The Nuclear Regulatory Commission has issued the enclosed Amendment No. 32 to Facility Operating License No. NPF-6 for the Arkansas Power & Light Company for the Arkansas Nuclear One Unit 2 plant. The amendment consists of changes to the Technical Specifications (TS) in response to your application dated March 5, 1981 as supplemented on May 3, 1982.

AMENDMENT TO FACILITY OPERATING LICENSE

Amendment No. 32
License No. NPF-6

SAFETY EVALUATION BY THE OFFICE OF NUCLEAR REACTOR REGULATION

Figure 1

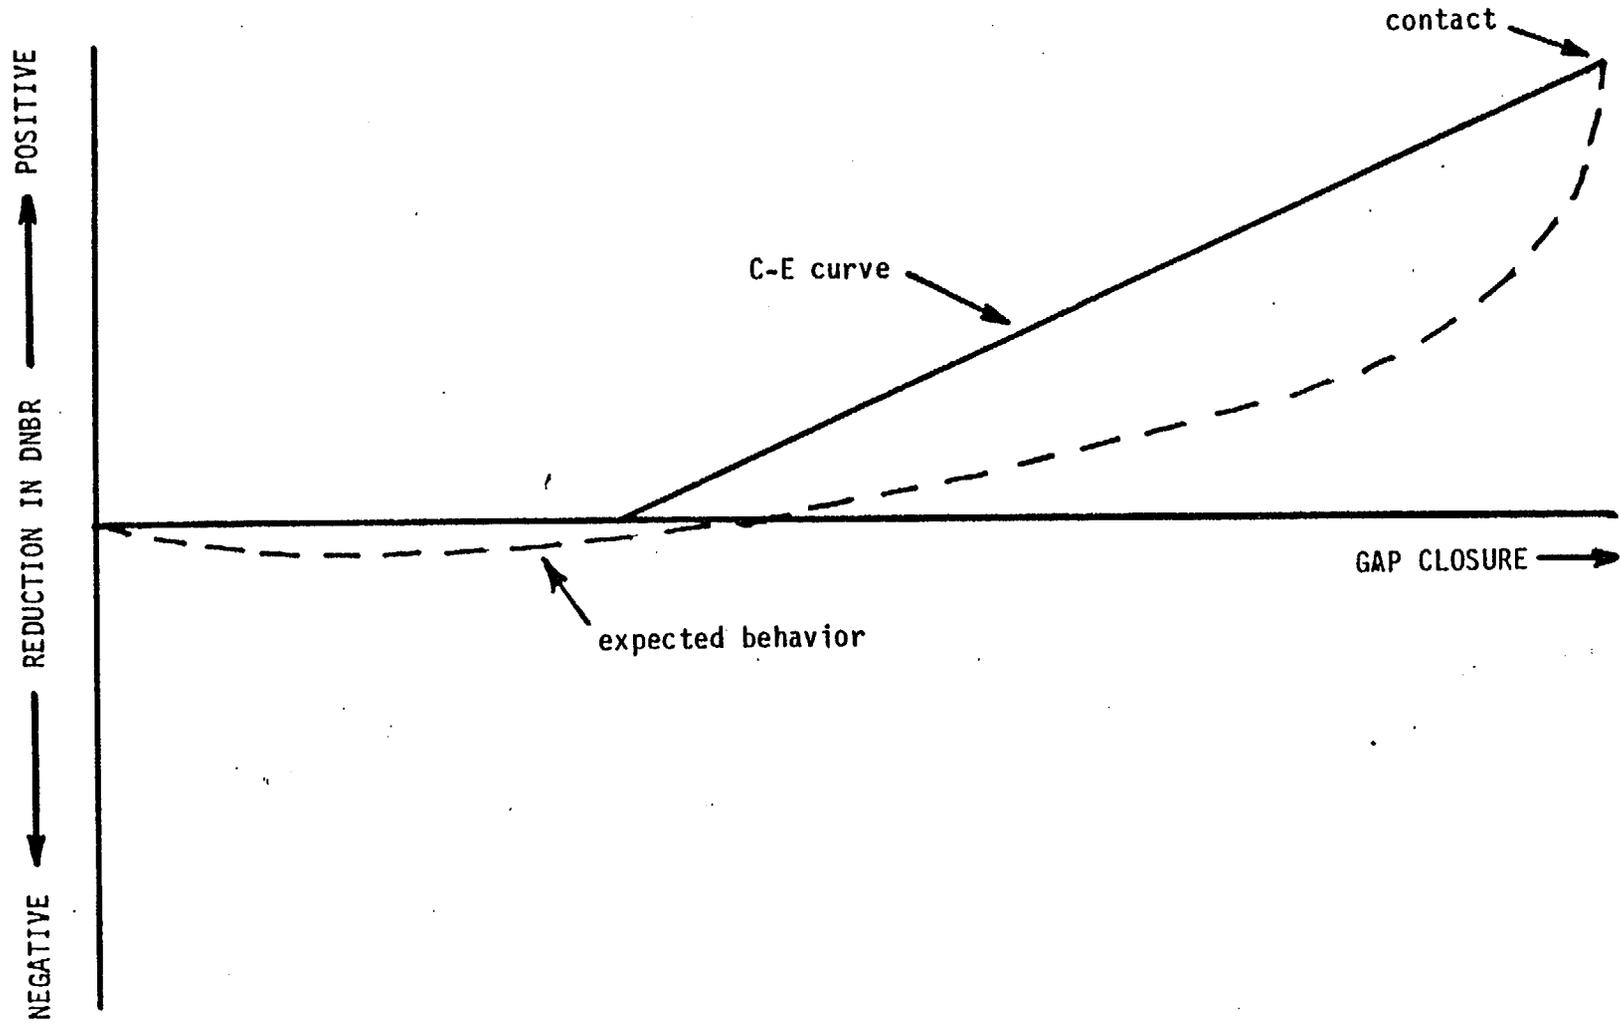
4. There is modeling conservatism in the treatment of reduction-in-DNBR as a function of gap closure. As shown in Figure 1, the proposed CE licensing curve (depicted by the solid linear line) bounds the expected behavior (hypothesized by the dashed curve).
